MONTGOMERY COUNTY HISTORIC PRESERVATION COMMISSION
STAFF REPORT

| Address: | 3704 Bradley Ln., Chevy Chase | Meeting Date: | 10/24/2018 |
| Case Number: | 35/13-18DD | Staff: | Michael Kyne |
| PROPOSAL: | Screened porch construction | | |

Proposed Overall Rear Elevation

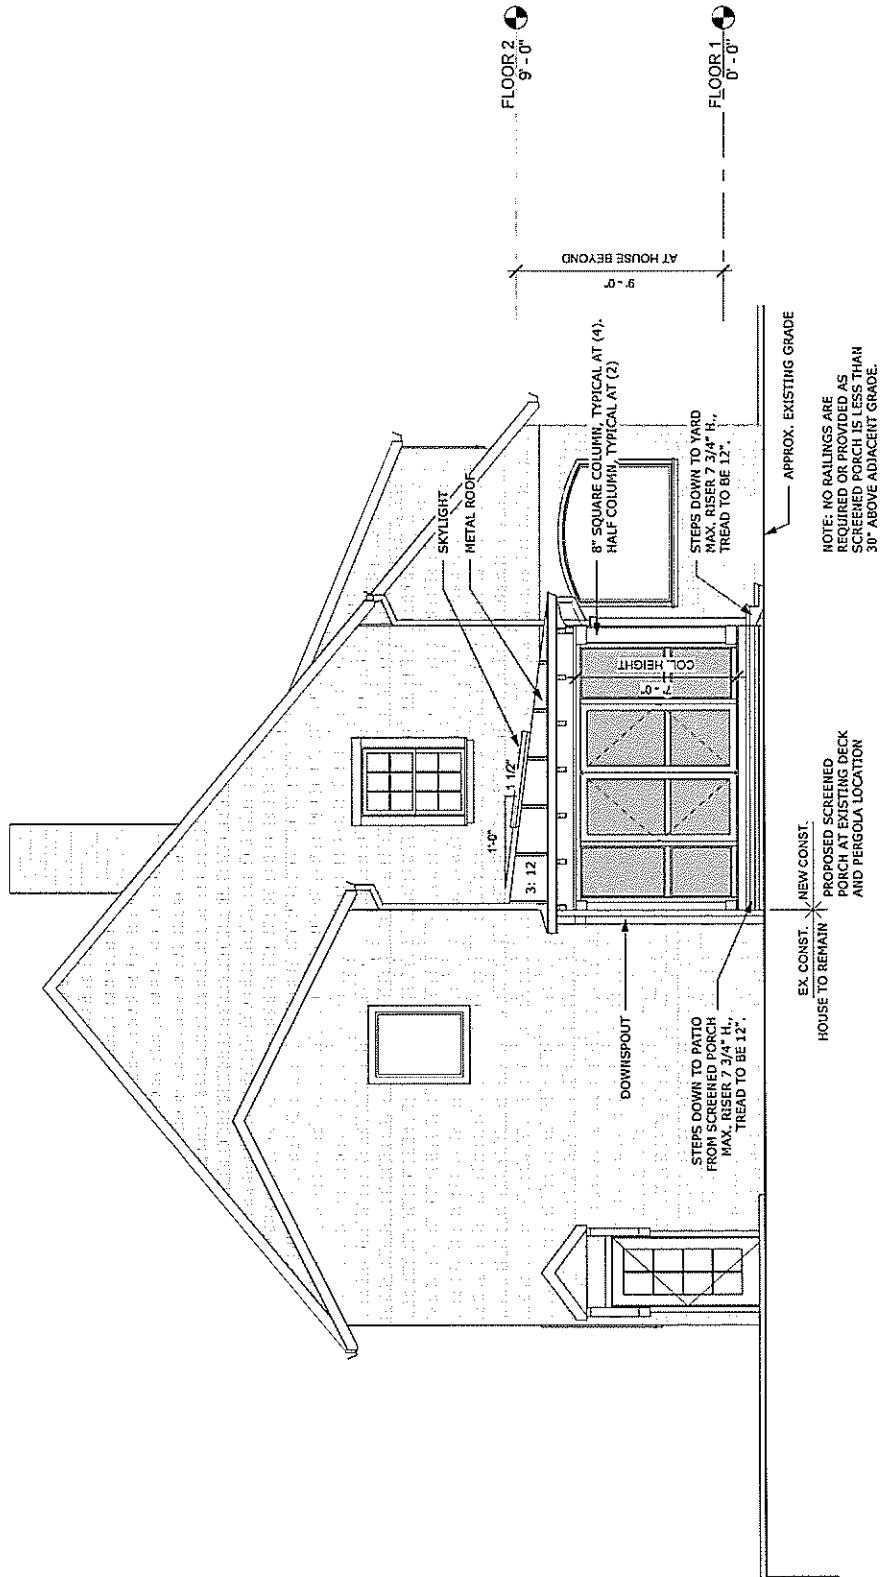
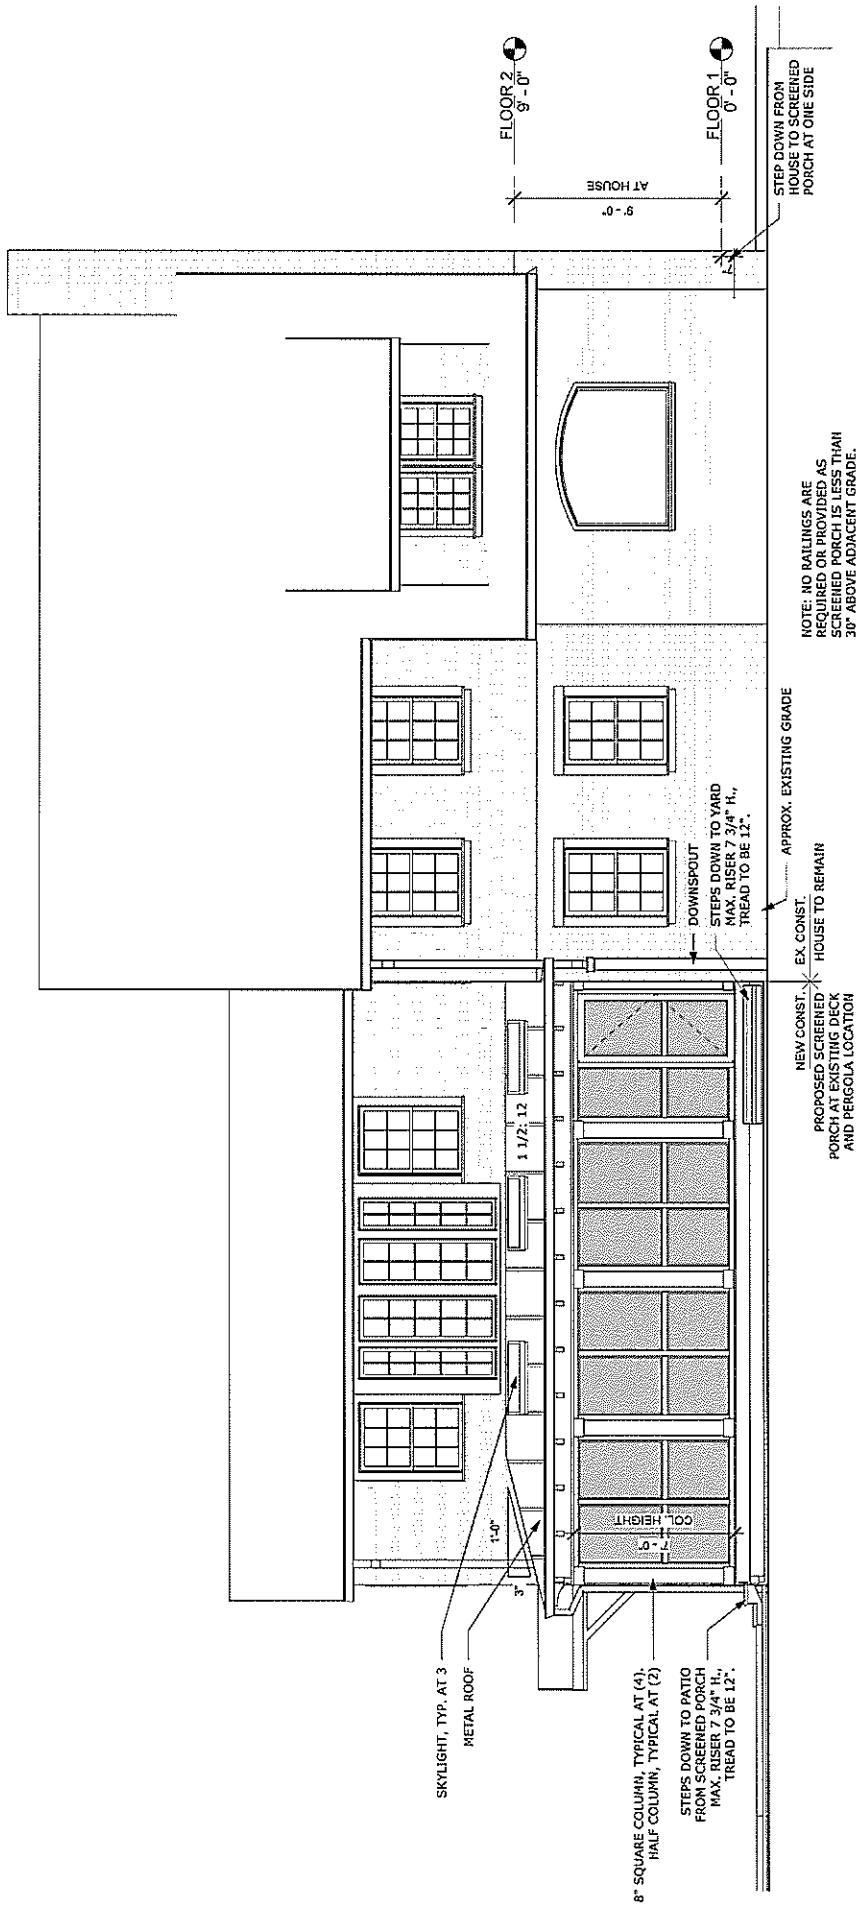
Staff is generally supportive of the applicants' proposal, finding that the location of the proposed screened porch is appropriate and will result in minimal visual change to the mass and form of the historic house; however, staff is concerned about the proposed standing seam metal roof. From the manufacturer's website, the proposed roof appears to be a prefabricated snap together system, which typically includes ridge caps and vents that are not consistent with traditional standing seam metal roofs. The seams available for the proposed roofing system appear to vary as well, ranging from low and wide to high and narrow. The proposed roofing system is not consistent with the character of the historic house or historic district.

Because the proposed screened in porch will be at least partially visible from the right-of-way (from oblique angles at the front on Bradley Lane and from the side on Brookville Road), staff recommends a

1. The proposed standing seam metal roof will be a traditional mechanically seamed roof without ridge caps or vents.

condition of approval, stipulating that the proposed standing seam metal roof will be a traditional mechanically seamed roof without ridge caps or vents. This will ensure that the proposed roof is compatible with the historic house and the surrounding streetscape, in accordance with *Standard #9*. It will also ensure that the proposed roof will not remove or alter character-defining features of the historic house, in accordance with *Standard #2*.
